CHANGES FROM BASE PRODUCT VBV-L4005 (3154) TO AC-056 (4401)

Assembly PI Approval S.ATTWOOD 13/03/14		Approved by G.PLITH		Checked by R.BATES		Drawn by P.MISSEN	
Angle of Projection 		Units mm	Scale N/A	Released 01/04/14		Assembly Ref -	
Third Angle		Status 01/04/14		AC-056			
		Part No 4401		BE-002831-00-14

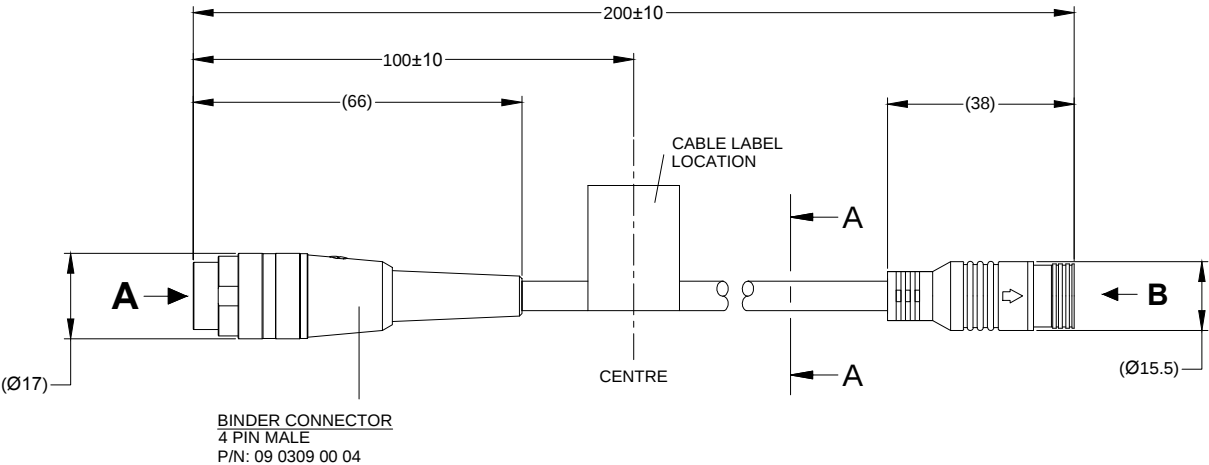
- CHANGE:
1. CUT CABLE TO REQUIRED LENGTH.
 2. REPLACE FEMALE CONNECTOR WITH 4 PIN MALE BINDER CONNECTOR.
 3. REMOVE RUBBER BOOT.
 4. REPLACE GENERIC CABLE LABEL WITH AC-056 CB-LBL.
 5. REPLACE GENERIC GIFT BOX LABEL WITH AC-056 GB-LBL.
